Modification 2 to MP 10_0229 - Concept Plan - Mixed Use Development, Cronulla Sharks (Part3AMod)

MP 10_0230 MOD 6 - Modification to Cronulla Sharks Stage 1 - Retail/Club Precinct (Part3AMod)

This is my objection to the proposed increases to the already approved development.

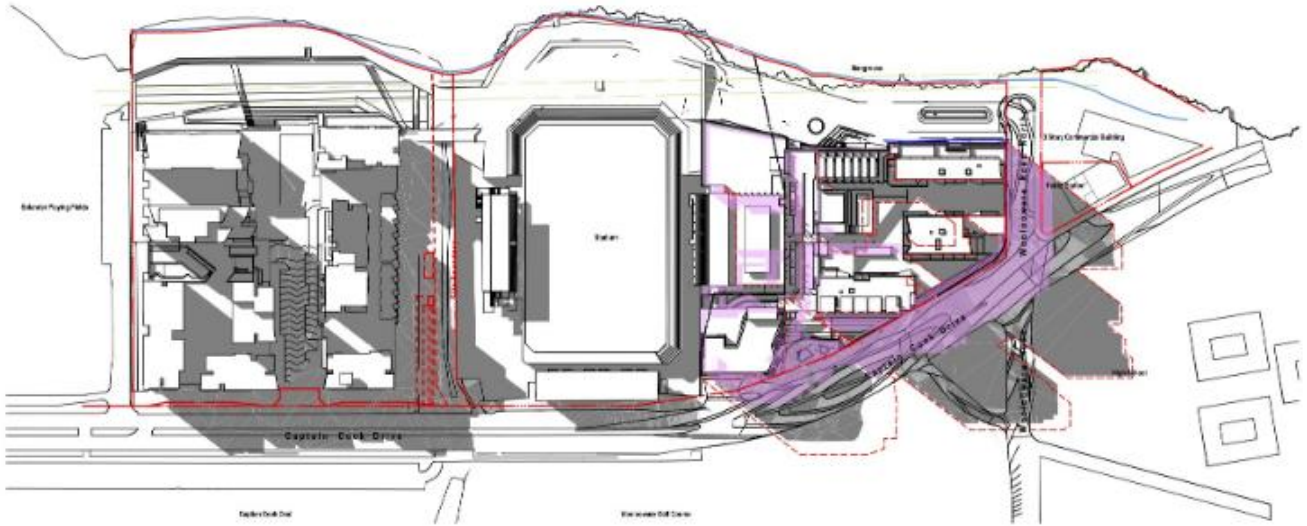
I object to the vastly increased bulk and scale of the proposed eastern precinct which will aggressively impact on the immediate low density neighbourhood because of the increased height, non-separated the building envelope that will be opaque to views of the skyline, and because of its greatly increased proximity to the low density area with such an abrupt change in development density which breaks all the rules of proper planning.

The photo montages clearly show doubling of blocking the view of Botany Bay.

The Preferred Project report had reduced the height of some buildings and amended some building footprints, reducing the visual scale of the development and improving through-site views.

These features formed part of the Director-General's report as a crucial part of justifying the Department's support of the Concept Plan, as stated in Section 5.6 Residential Amenity where the significant words are “improving the site views from the surrounding locality”.

Even this moderate gain for the community will now be lost. It is totally unfair!

Shadow Diagram Proposed
21 June 2pm
1:2000

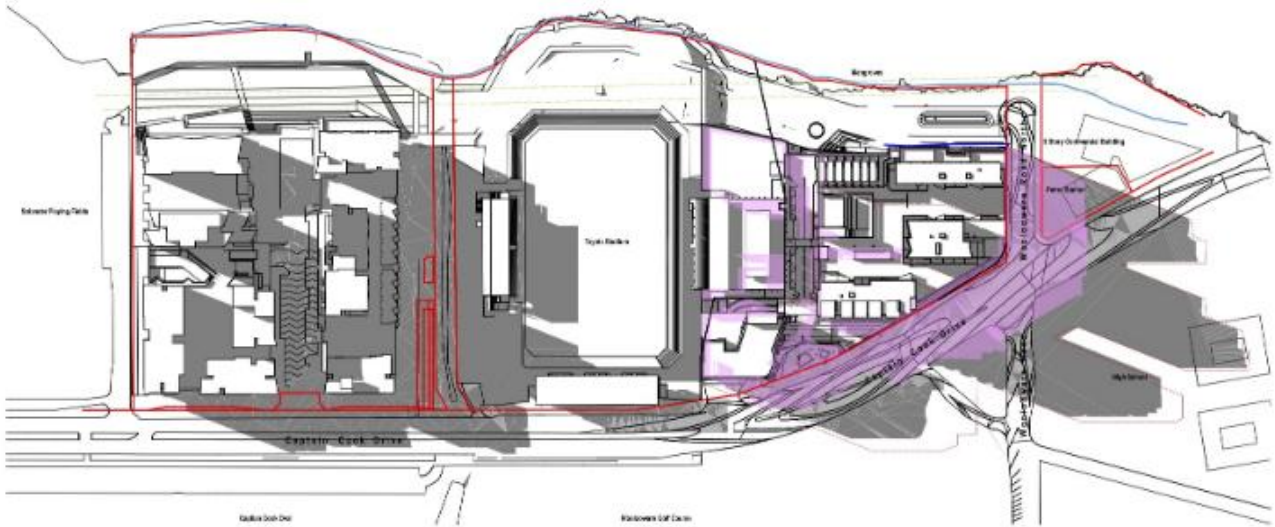
The Section 75W report selectively omits the critical 3PM case, which could be found only among the architectural drawings, and which shows drastic overshadowing of Woollooware High School.

Following are the 2PM case which was shown in the Section 75W report, and the omitted 3PM case which is perhaps too graphic and might upset readers if it were included in the Section 75W report.

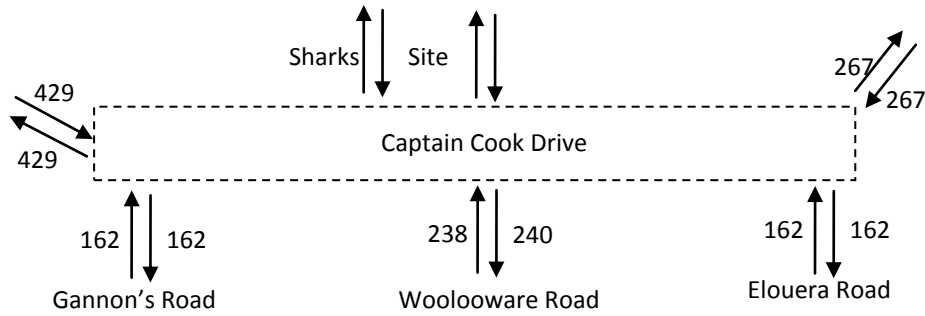
Irrespectively, the consultant’s traffic generated traffic figures for high density residential of 65 vph for Friday peak and 17 vph for Saturday peak are for only the 222 extra units and don’t include the approximately 600 already approved. More traffic underestimation!
